Service Bulletin

Bulletin No.: 17-NA-221

Subject: Poor Engine Performance in Extremely Cold Weather Conditions for LE2 Engines, Charge Air Cooler Icing - Malfunction Indicator Lamp (MIL) Illuminated, DTC P0299, P0234, P0236, P2227, P00C7 Set

5197596

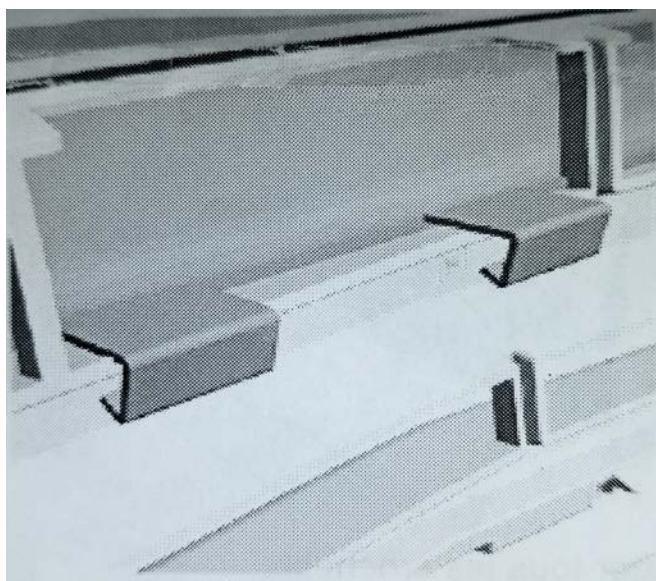
1. Using care, orientate the fascia winter cover to the bumper fascia.

2. Attach the cover to the fascia by pushing the hooks through the grille openings.
3. Validate that all the hooks are engaged and the cover is a tight fit.

4108751

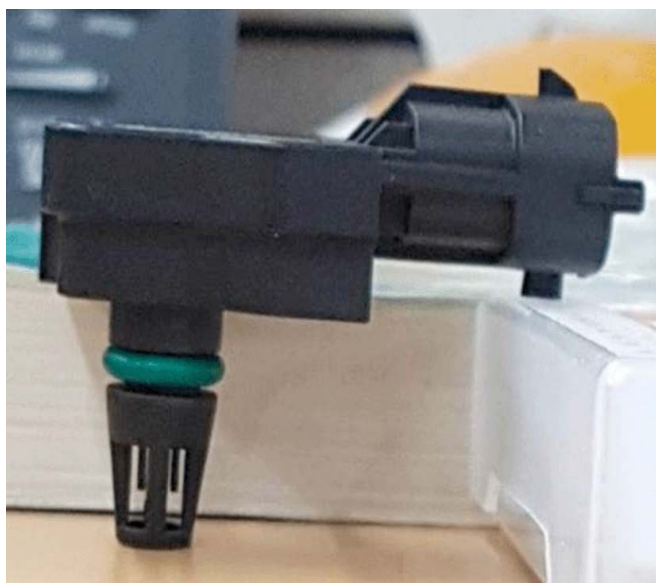
1. Remove the turbocharger Air Pressure sensor (3). Refer to *Turbocharger Air Pressure Sensor Replacement* in SI.

2. Inspect the sensor for any contaminants.

3. Allow time for any ice build-up to melt by placing the sensor port down.
4. Clean the sensor with a clean towel.
5. Install the sensor.

2851444

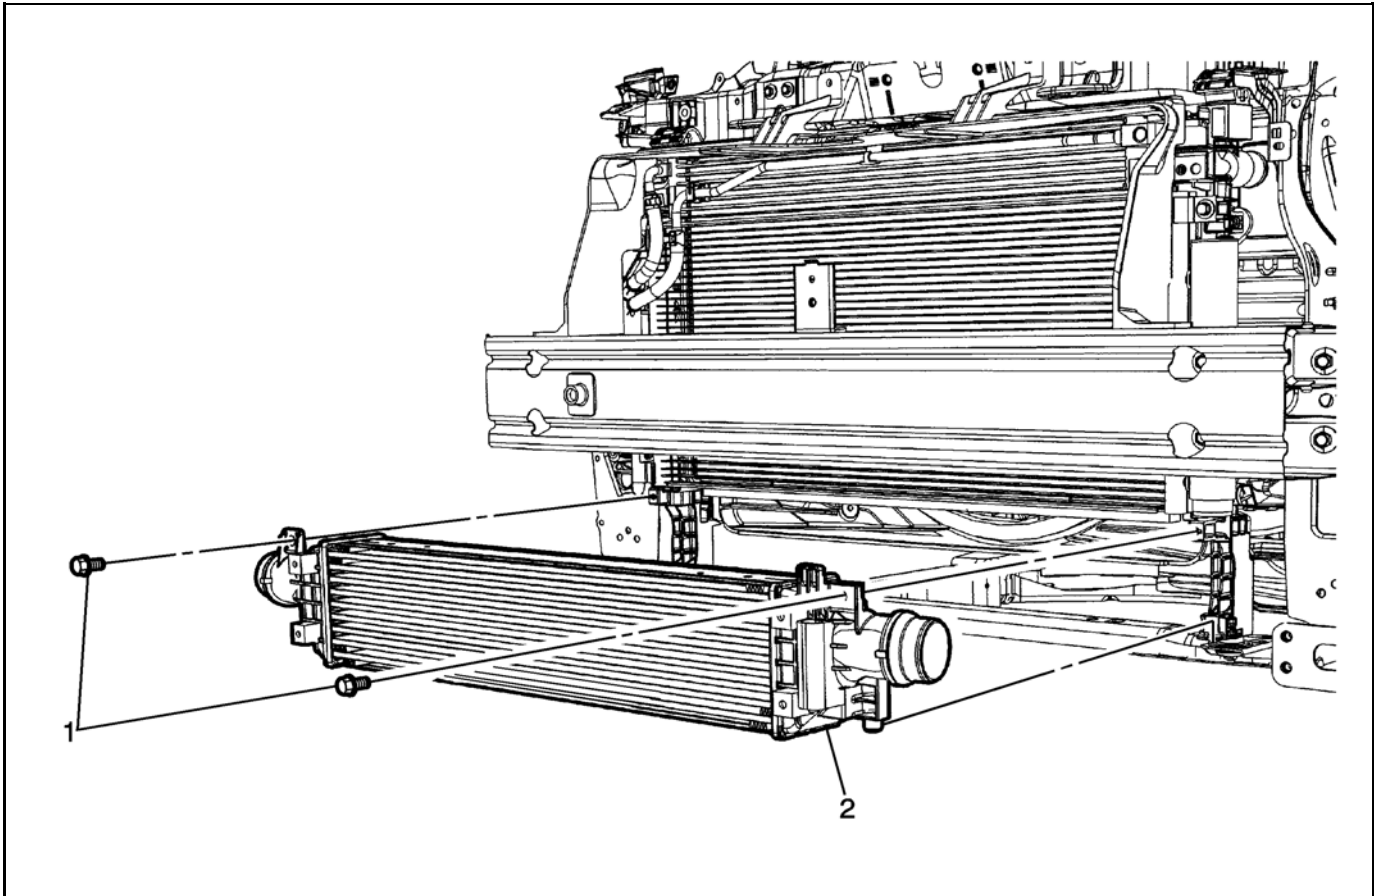
1. Install the CAC (2). Refer to *Charge Air Cooler Replacement* in SI.
